# State of West Virginia Purchase Order

Order Number:	CPO 0211 4004 GSD2300000002 11	Procurement Folder:	969527
Document Name:	Building 4 Renovations Project	Reason for Modification:	Change Order #7 To increase the contract.
Document Description:	Building 4 Renovations Project		
Procurement Type:	Central Purchase Order		
Buyer Name:	Melissa Pettrey		
Telephone:	(304) 558-0094		
Email:	melissa.k.pettrey@wv.gov		
Shipping Method:	Best Way	Effective Start Date:	2022-10-03
Free on Board:	FOB Dest, Freight Prepaid	Effective End Date:	2024-12-25

## Document G701® – 2017

**PROJECT: (Name and address)**  
22010.00 Building Four Renovations  
Project  
112 California Avenue, Charleston, WV  
25305

RFI #: 104  
Date: 4/23/2024  
Job: 22-22 State Office Building 4 Renov  
Phone:

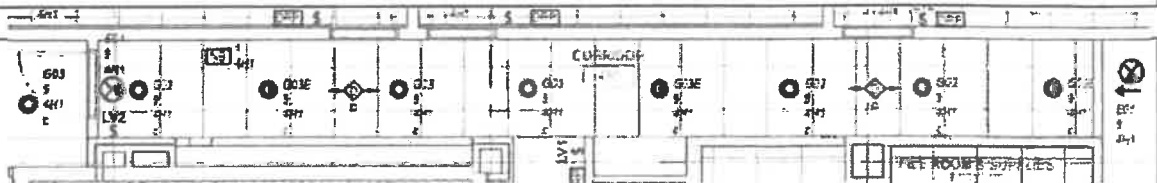
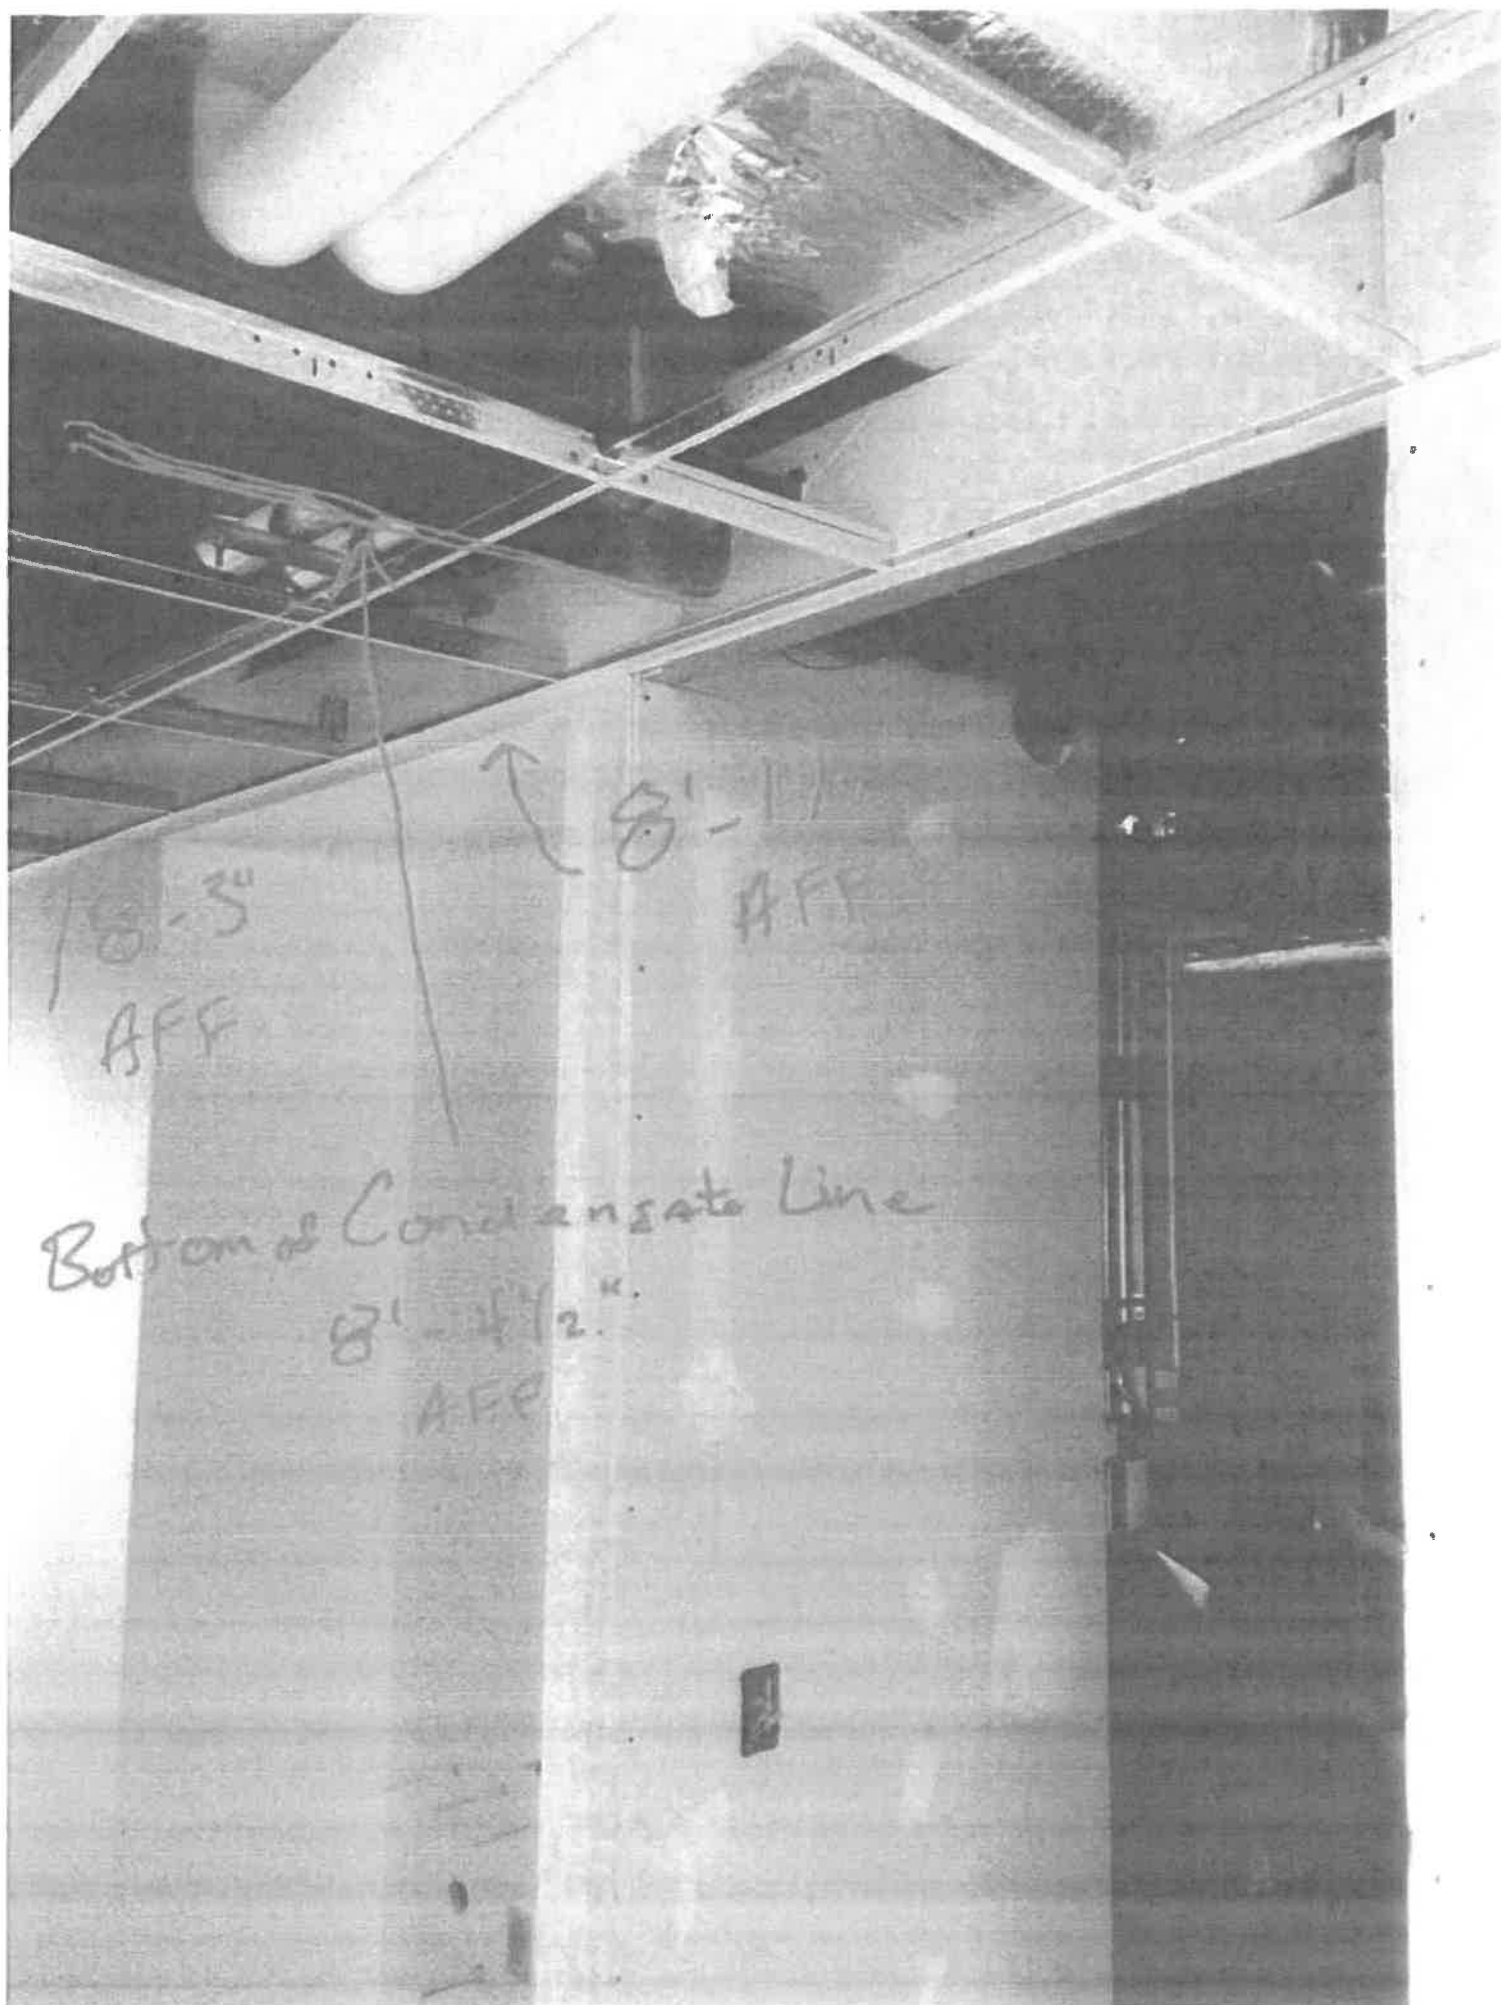
Drawing EL-104 calls for Type G03 and G03E Fixtures in Corridor 450. The G03 and G03E light fixtures are 6 deep. With the added drain pan for the SCB in this Corridor, the elevation of the condensate line does not allow for the light fixtures as designed to fit in the above ceiling space. Due to existing conditions, the ceiling cannot be lowered (see attached photos). This is not a coordination issue, but instead a change in conditions after the drain pans were added that does not allow for sufficient space for the 6 deep light fixtures. Our suggestion would be for an alternative lay-in panel light to be purchased instead of the can light. See attached cutsheet for suggested alternative light fixture. Additional costs would apply for the new light fixture. Please advise.

\* PWWG SUGGESTED ROUND FLAT LIGHT FIXTURES  
INSTEAD OF 2X2 FLAT LIGHTS. REVIEWED RFI #104  
ON SITE. CORRIDOR 450 HAS LIMITED SPACE.
